Project: **PROPOSED 6-STOREY RESIDENTIAL & COMMERCIAL BUILDING**
Civic Address: Fort Street & Davie Street, Victoria, BC
Date: April 30, 2024 Project Number: 22600

MEMO

Please find below responses to the outstanding items identified in your Application Review Summary received October 12, 2023, for Rezoning DP Application (REZ00859 & DPV00248).

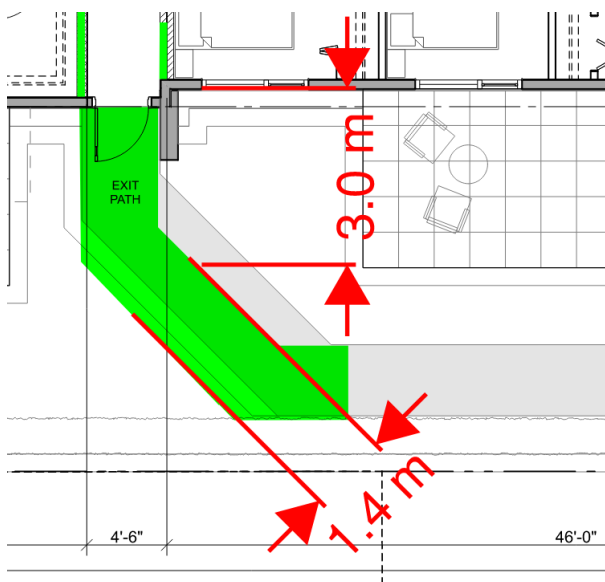
§ Designer to provide the spatial separations and unprotected openings calculations meeting BCBC.

Response: Please refer to DRAFT code report dated August 28, 2023. A more updated Code report to be provided during Building Permit stage.
